Technical Information Bulletin

42-056

Composite Coolant Fitting Leak

Replace Composite Coolant Fittings with Brass

Port A, Option 1

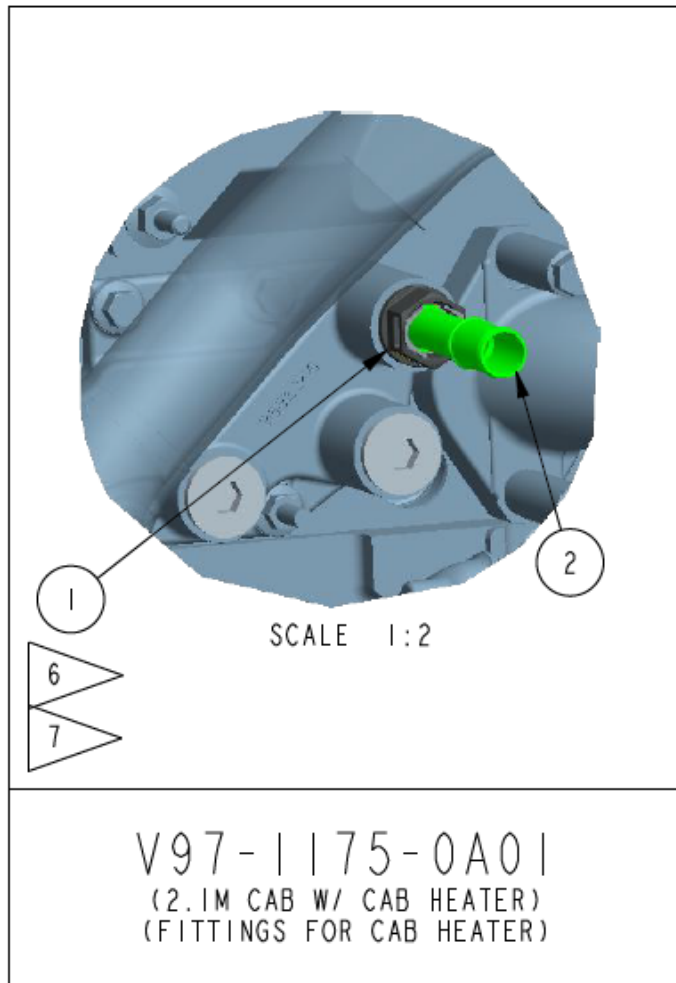
- 2.1m Cab Heater
- Brass: V38-1089
- Composite: V38-1166 and V88-1123-6*

Port A, Option 2

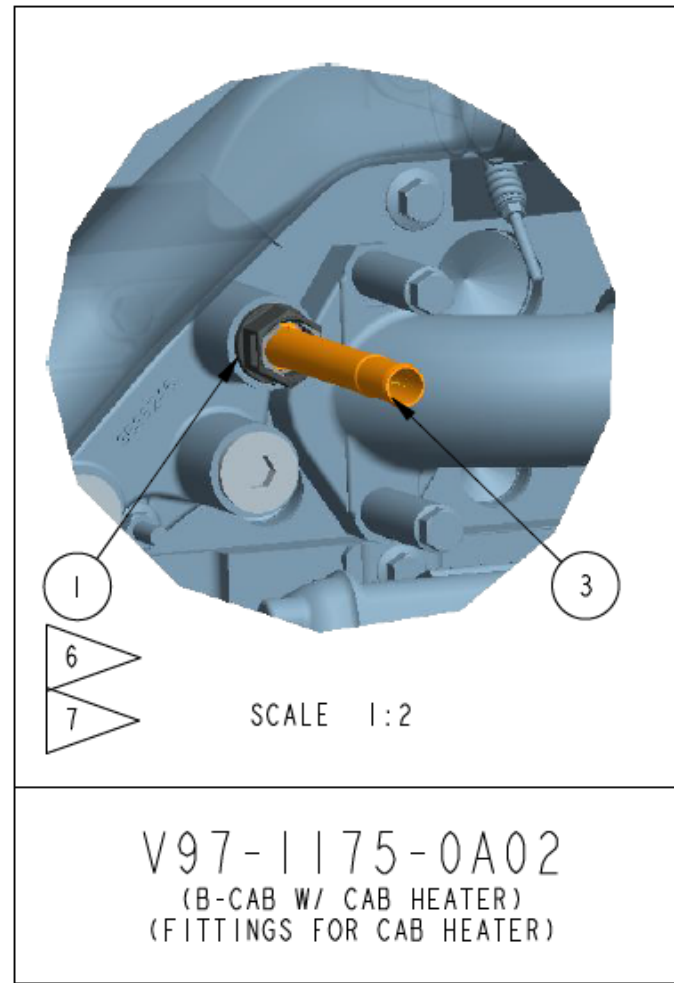
- 1.9m Cab Heater
- Brass: V38-1018
- Composite: V38-1166 and V88-1123-5*

Port R

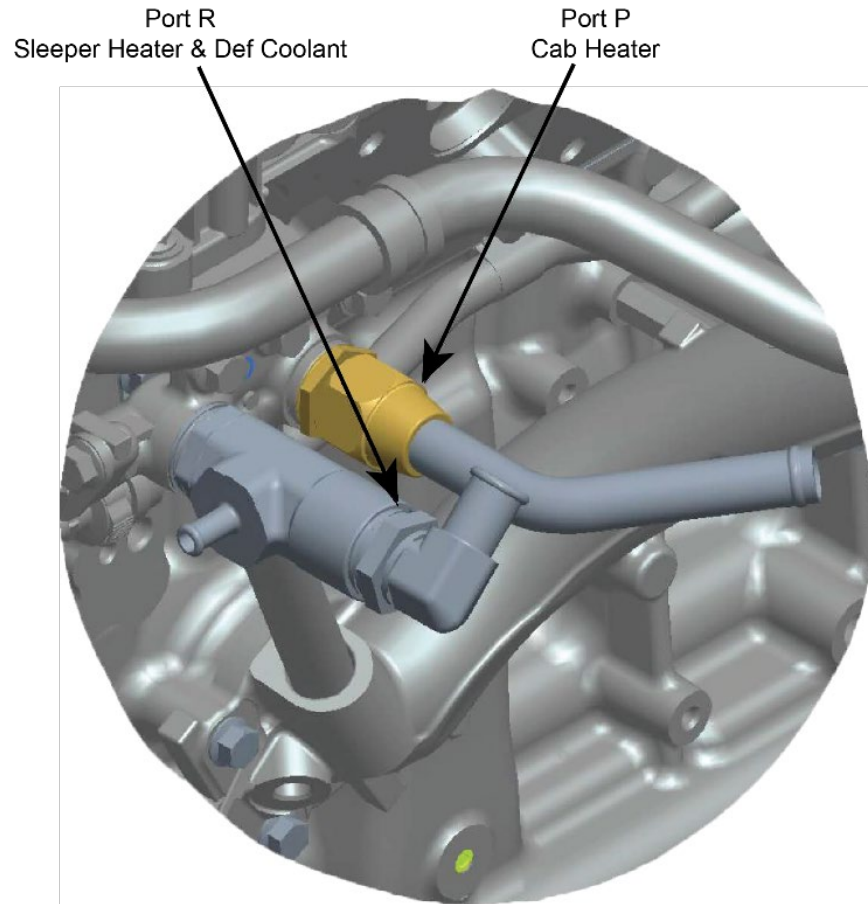
- Brass: V38-6040 & D2034-6707
- Composite: V38-1166 & V88-1145

DEF Only

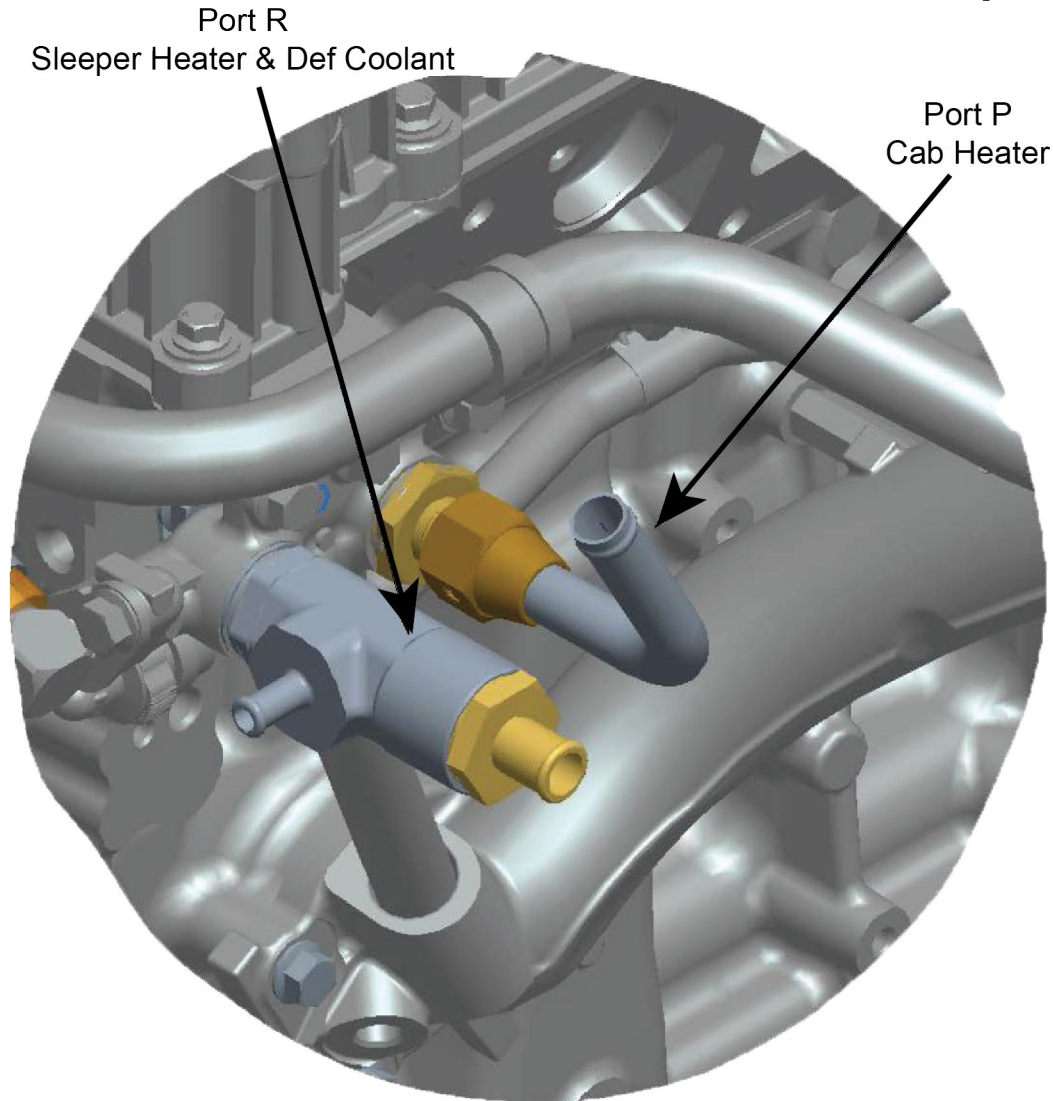
- Brass: V38-6041
- Composite: V38-1166 & V88-1143

Port A, Option 1

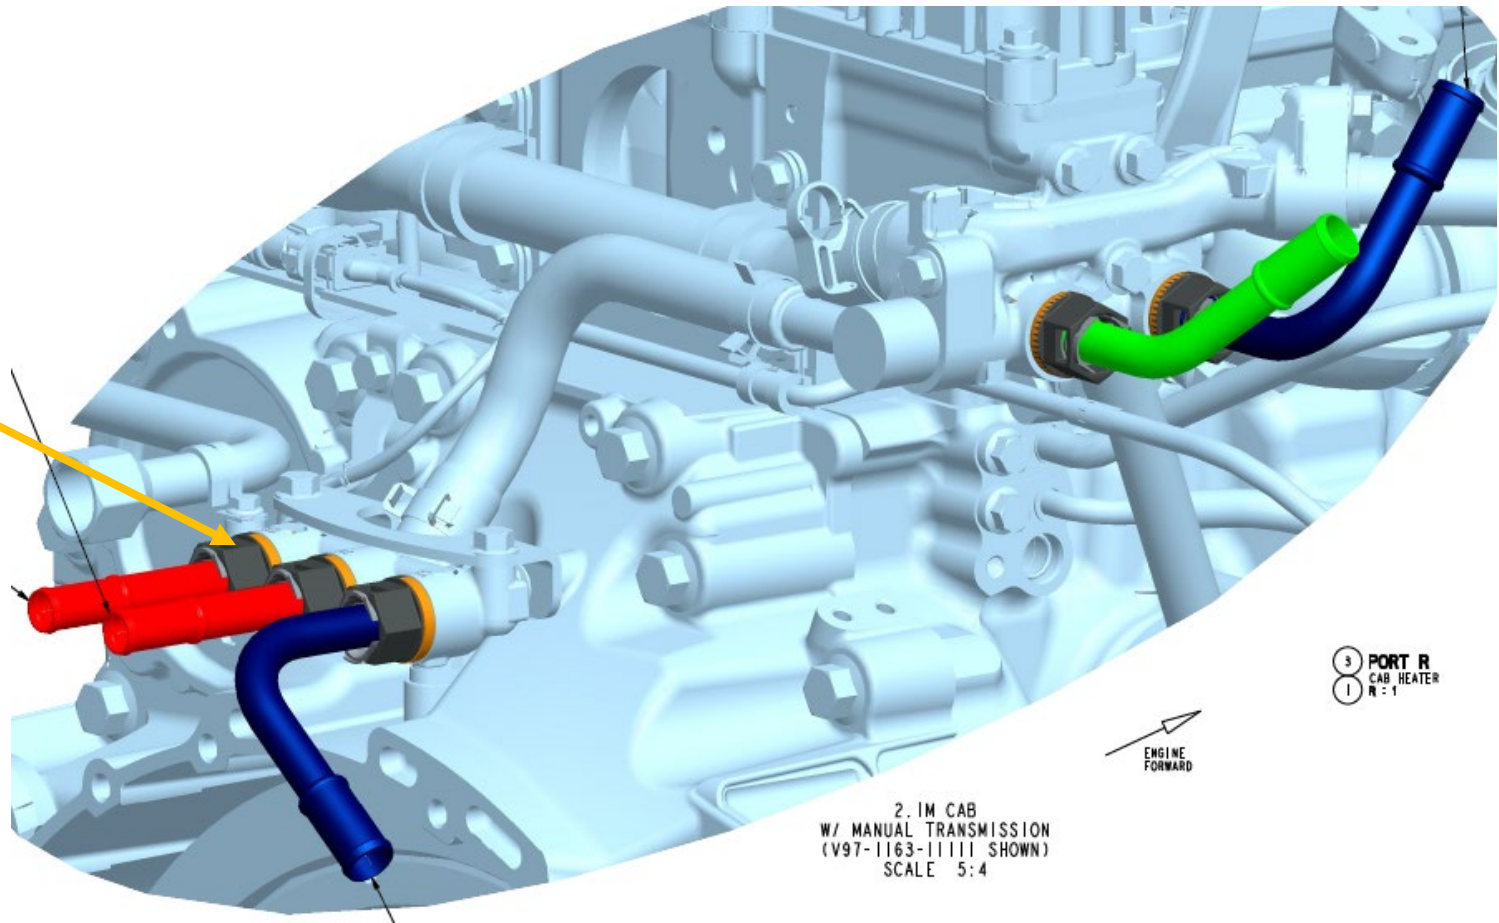
- Manual Trans Cooler
- Brass: V38-1090
- Composite: V38-1166 & V88-1123-6*

Port C

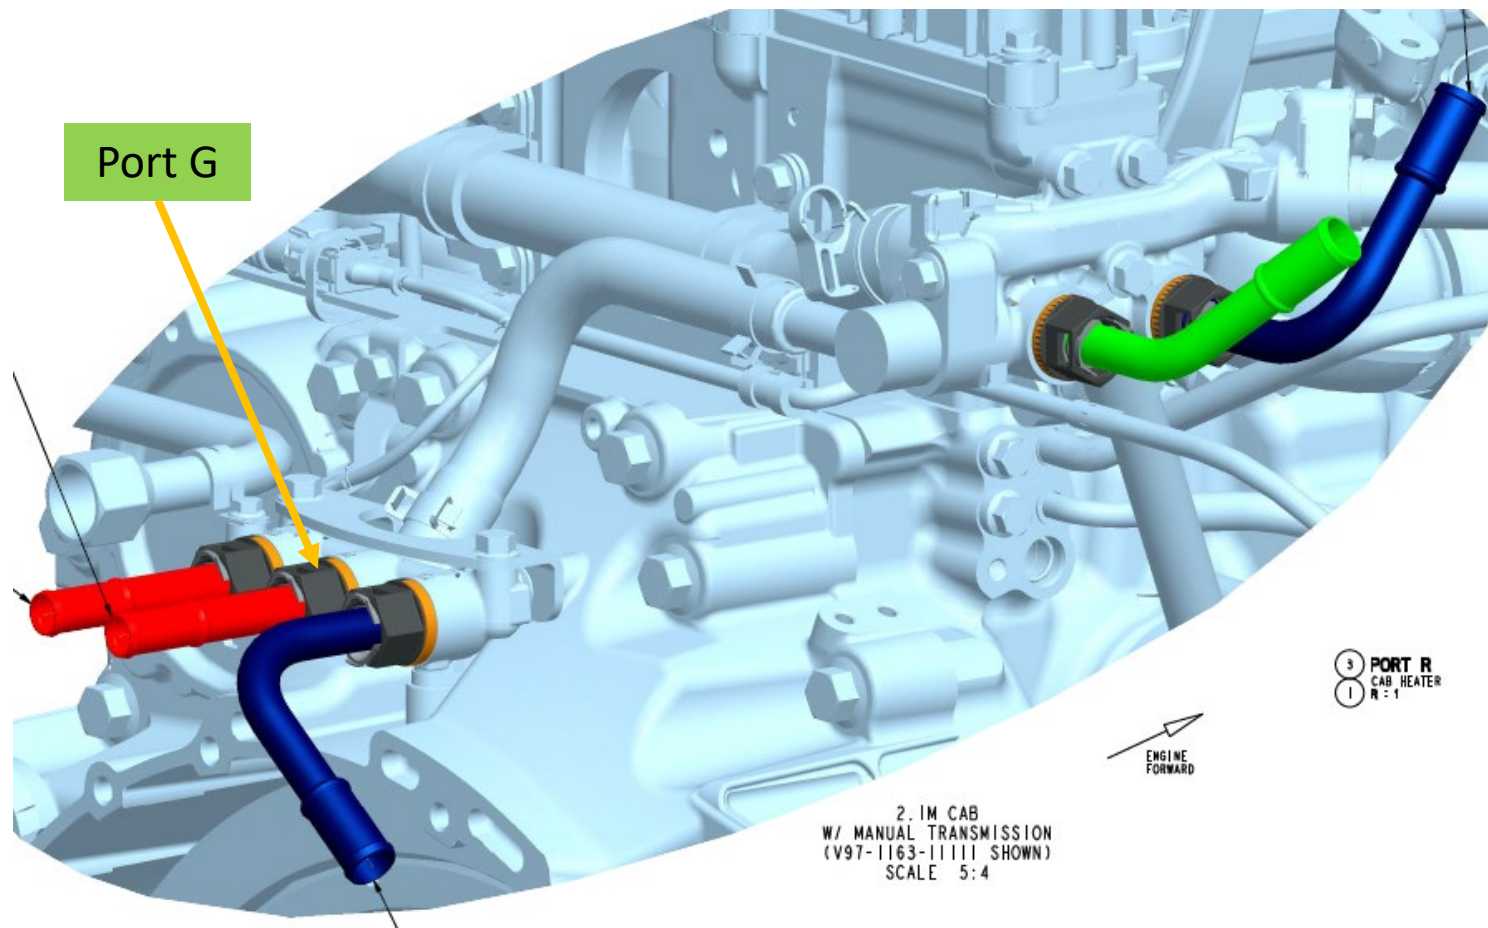
- DEF Port w/ Manual Trans Cooler
- Brass: V38-1018
- Composite: V38-1166 and V88-1123-5*

Port G

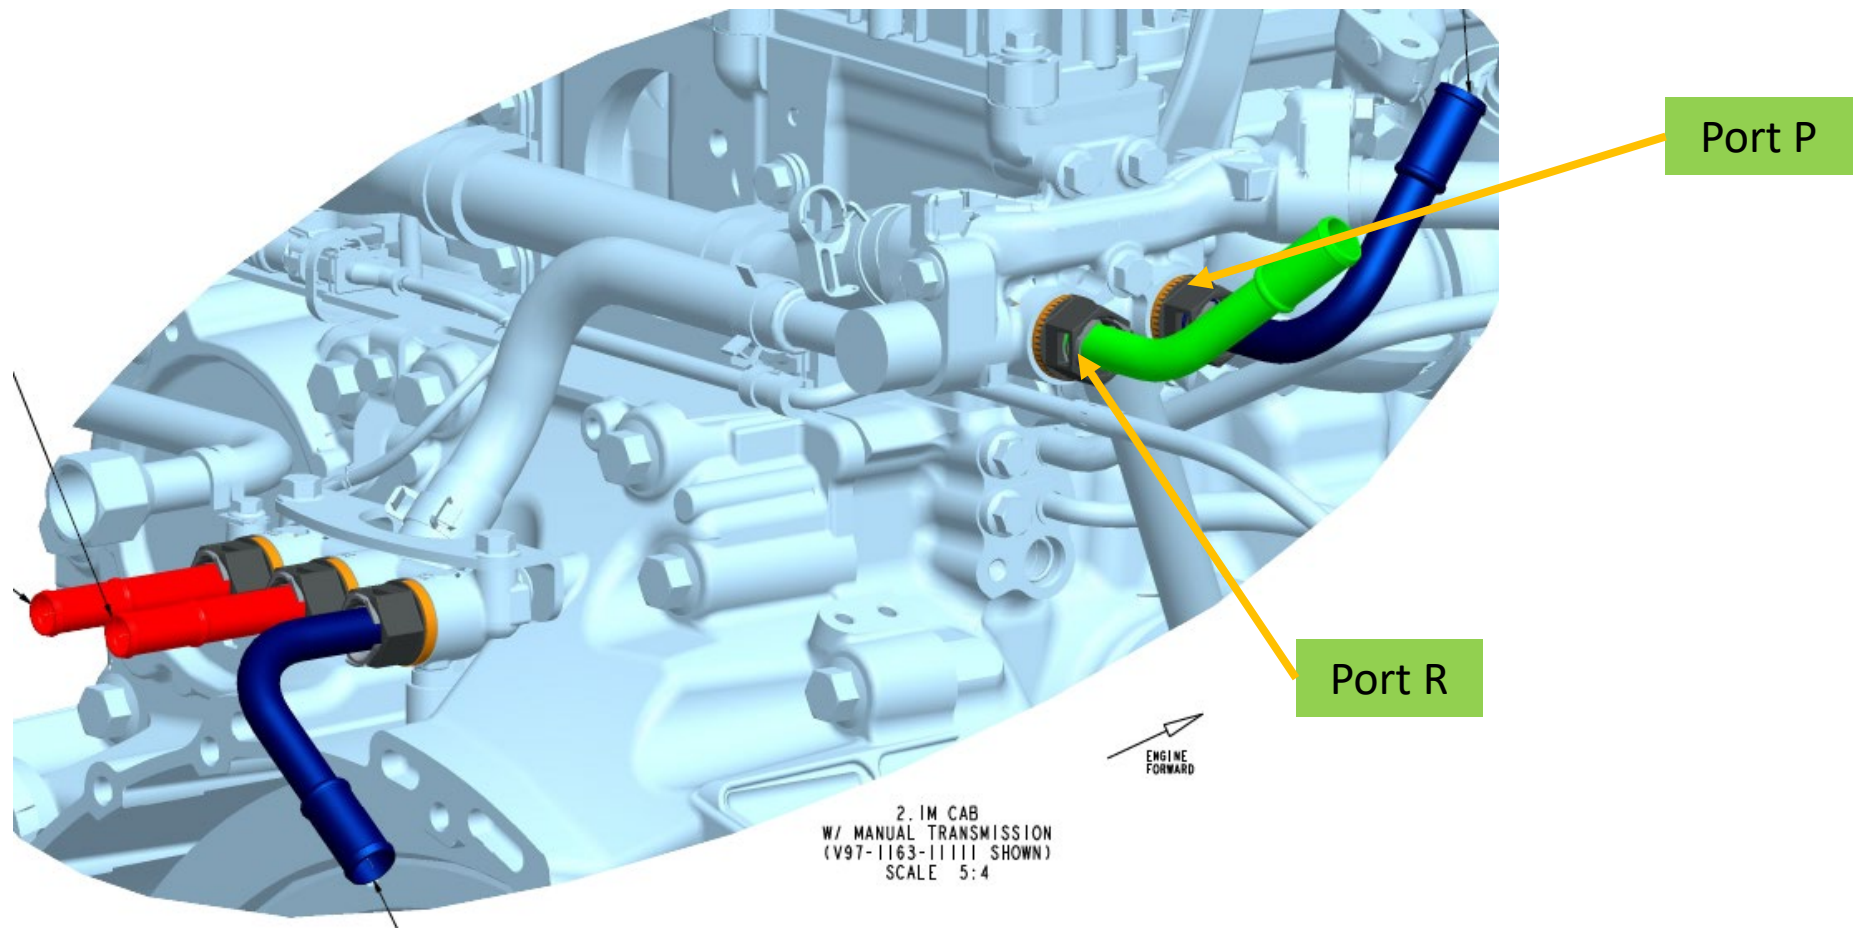
- Aux Heater or Drivetrain Cooler
- Brass: V38-1018
- Composite: V38-1166 & V88-1123-5*

Port A, 2.1m or 1.9m, Option 1

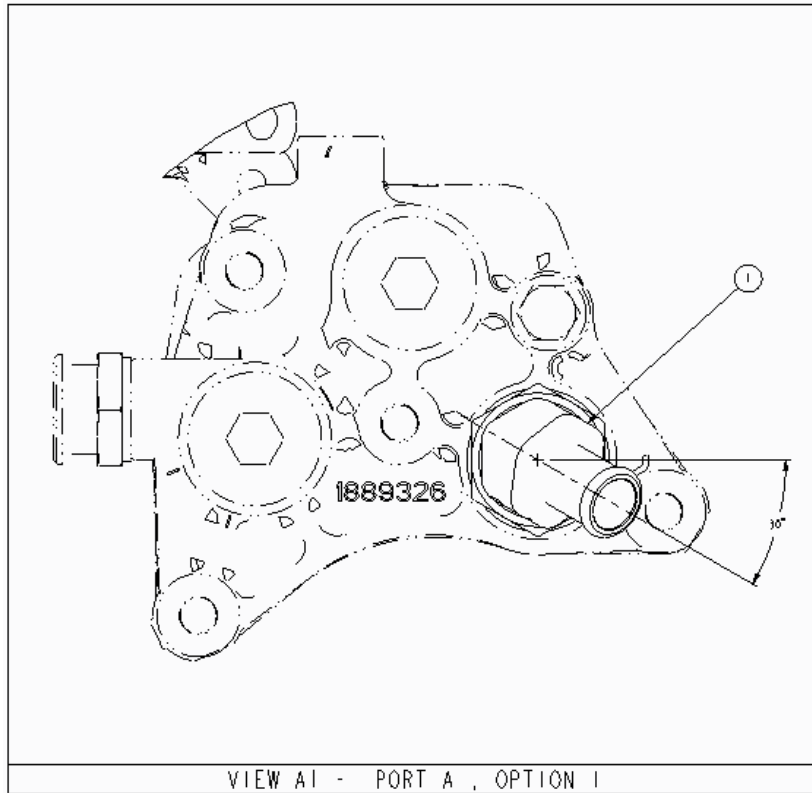
- DEF Port w/o REPTO
- Brass: V38-1088
- Composite: V88-1123 & V88-1123-545*

Port A, 2.1m or 1.9m, Option 2

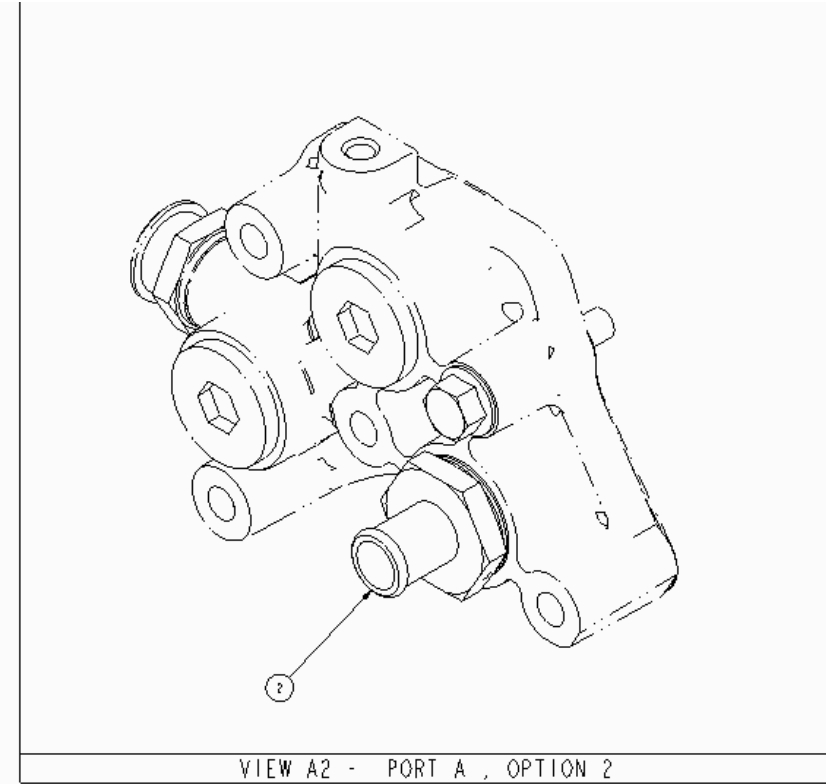
- DEF Port w/ REPTO
- Brass: V38-1018
- Composite: V88-1123 & V88-1123-500*

Port C, 1.9m Option 1

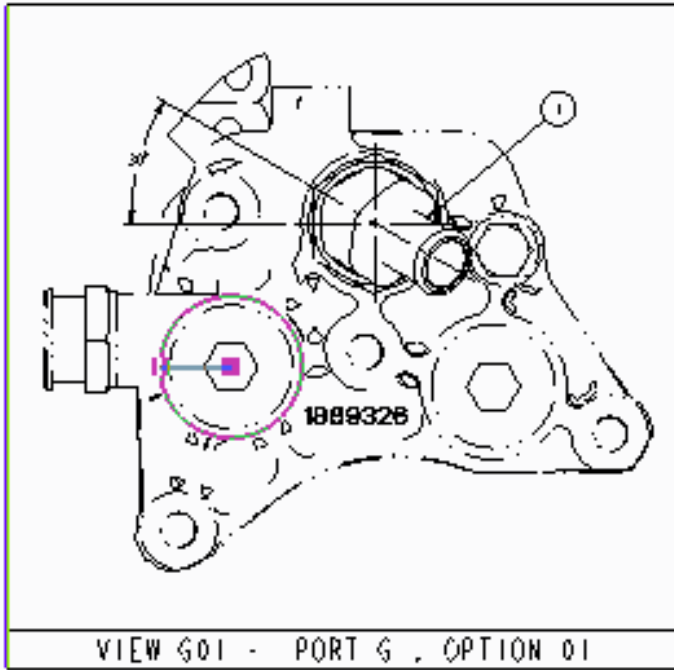
- Manual Tmsn Cooler
- Brass: V38-1090
- Composite: V38-1166 & V88-1123-645*

Port G, Option 1

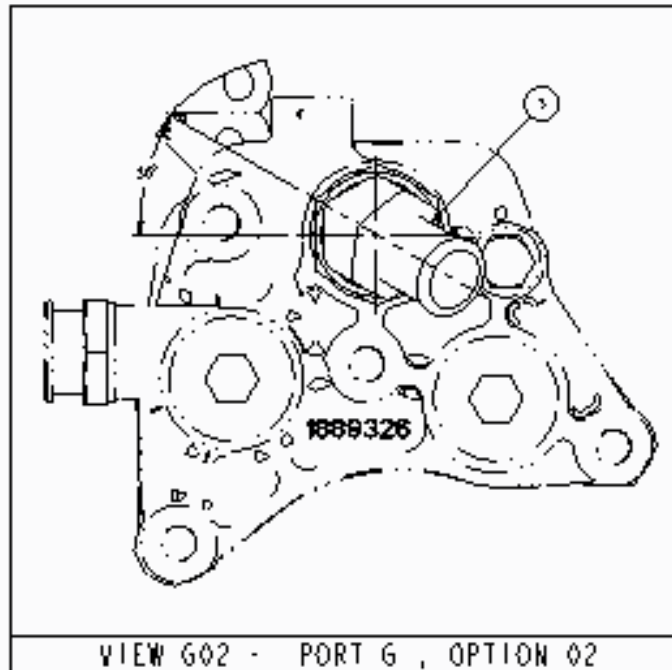
- 1.9m Aux Heater
- Brass: V38-1088
- Composite: V38-1166 and V88-1123-5*

Port G, Option 2

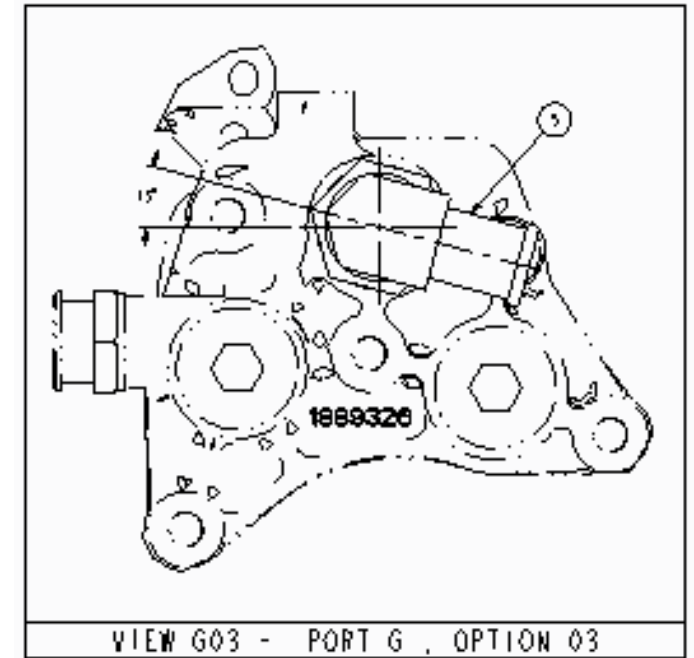
- 2.1m Drivetrain cooler w/ high route exhaust
- 1.9m Drivetrain Cooler
- Brass: V38-1090
- Composite: V38-1166 and V88-1123-6*
